# Vashon-Maury Island GWPC Overview and Comment - July 28, 2010: Vashon-Maury Island Phase II Hydrologic Model

The Vashon-Maury Island Groundwater Protection Committee (GWPC) has reviewed the Vashon-Maury Island Hydrologic Modeling Technical Report (Report) (DHI Water and Environment, 2009). Development of a hydrological model is a part of the Vashon-Maury Island (VMI) Water Resources Evaluation (WRE) and was undertaken in 2004 to evaluate ground water and surface water quantity and quality and to refine earlier efforts at developing an island-wide water budget. The Report describes a Phase II model (MIKE SHE) containing improvements over an earlier version (MOD FLOW). The Phase II model was run to attempt to assess the impacts of partial buildout<sup>1</sup> under local zoning, climate change, and combinations thereof in future years. This overview summarizes the GWPC's perspective on the model's use, its limitations, and future work that needs to be done. Key points are:

## Attachment: Comparison of deep well log data to model assumptions

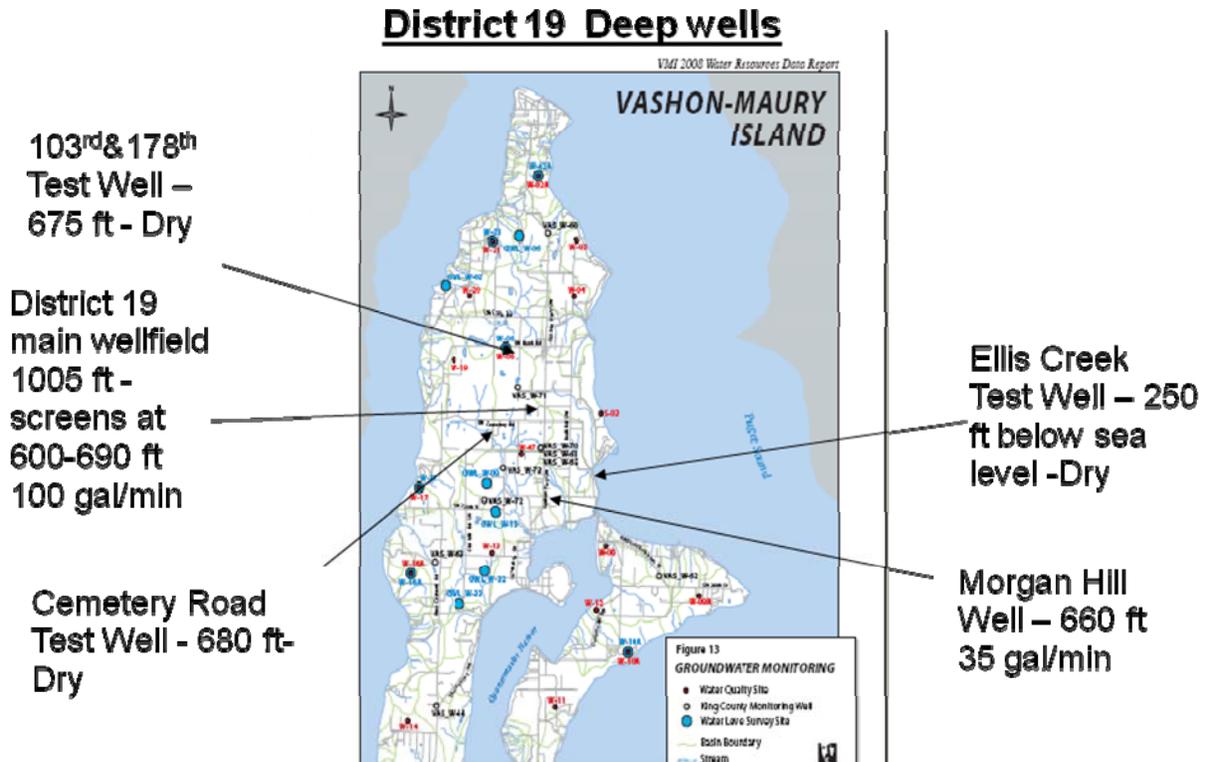
This is illustrated by looking at examples of actual well log data from specific areas and comparing them to the model. See attachment: Comparison of deep well log data to model assumptions. The well log data does not synch up very well with model inputs in these locations. The model layering provides an island-wide rather than local approximation of conditions.

The Figure above shows the deep wells that were compared to the computer model, as a reality check. There are only a few deep wells on the Island. The deep well logs at these locations were entered in Excel and graphed, so that the scale of the layers could be quickly, visually assessed. Note that three wells are dry, which is the situation for a fairly large portion of the Island. The model is based on three hypothetical continuous aquifer layers that extend across the entire Island.

## At 103<sup>rd</sup> and 178<sup>th</sup>: Comparison of computer model vs well log

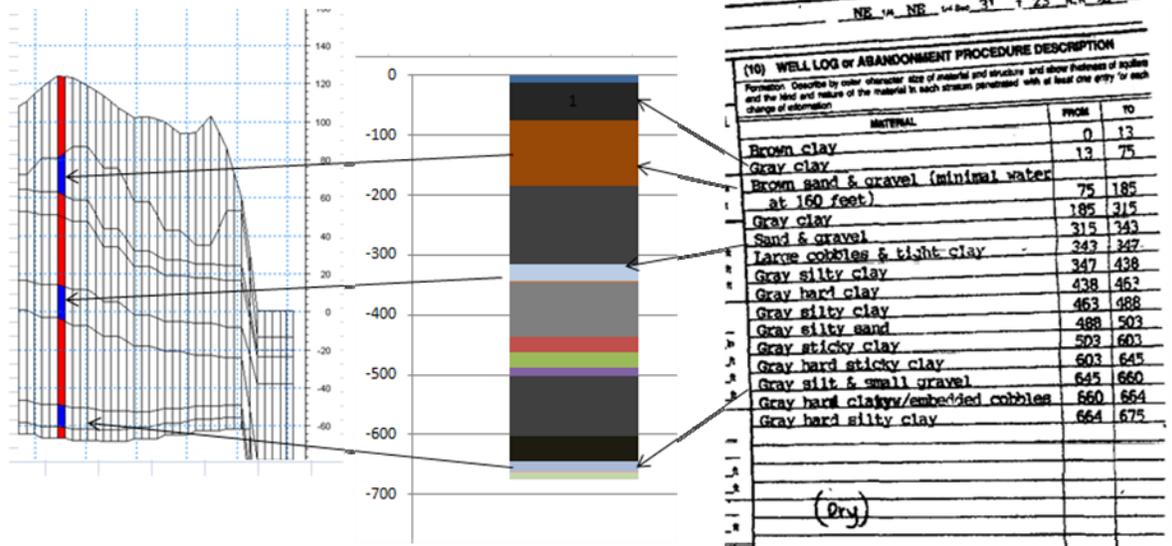
Computer model shows 3 continuous water bearing layers

Well log shows a dry well, overlain with hardpan. Well has gravel, but little water
